BCA & Access Assessment Report

Proposed Multi Level Warehouse Facility
49 Stephen Rd. Banksmeadow, NSW 2019

Prepared for:
ESR

Revision 7
25 March 2026
Reference: 230396

Figure 2: Perimeter Vehicular Access Assessment

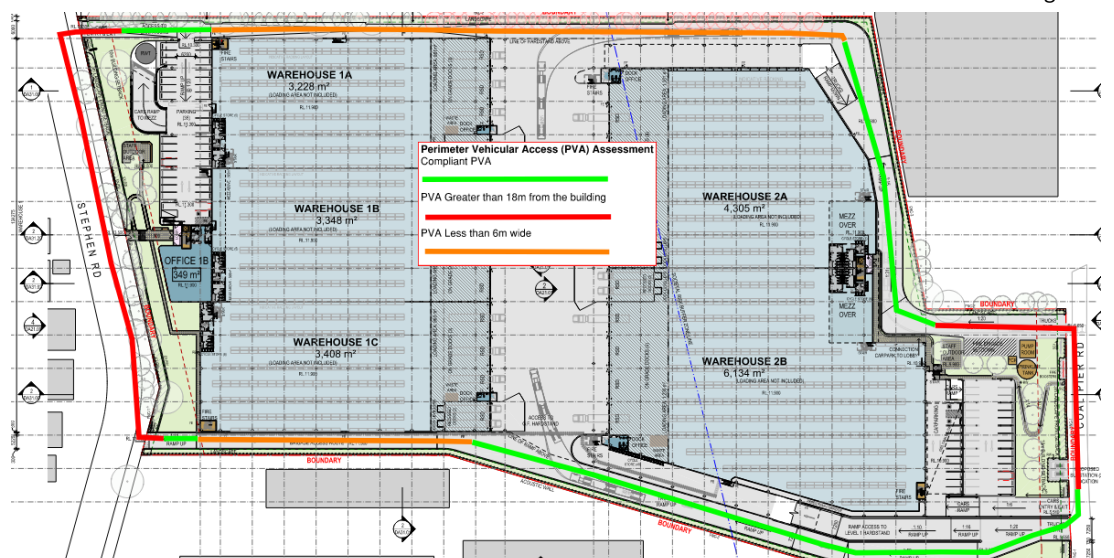
Comment: The proposed building does not comply with the provisions of C3D5 and thus the following non-compliance issues are required to be addressed as a Performance Solution by the Fire Engineer to demonstrate compliance with Performance Requirement C1P9:

- + To allow PVA to be greater than 18m from the building on the eastern and western sides of the building.
- + To allow PVA to be less than 6m wide on the northern and southern sides of the building.

Note 1: Any proposed gates are to achieve no less than 6m unobstructed width or the reduced width will need to be included in the above Performance Solution. Note 2: The driveways providing vehicular perimeter access must be designed with adequate loading capacities, gradients and swept paths to accommodate a fire truck, having regard to the FRNSW Fire Safety Guideline – Access for Fire Brigade Vehicles and Firefighters. Note 3: The Trial Design for the Fire Engineered Performance Solution must take into consideration and detail the proposed security access to the site and how this may impact on FRNSW vehicular access.
C3D7	Vertical Separation of Openings in External Walls: In a building of Type A construction, any part of a window or other opening in an external wall is above another opening in the storey next below and its vertical projection falls no further than 450 mm outside the lower opening (measured horizontally), the openings must be separated by a fire-rated spandrel, or a horizontal fire-rated extension. Comment: The proposed building is required to be sprinkler protected throughout and thus does not require fire rated spandrels to protect openings in the external walls between each level. Note: These provisions above do not apply to the Class 10 buildings on the site.
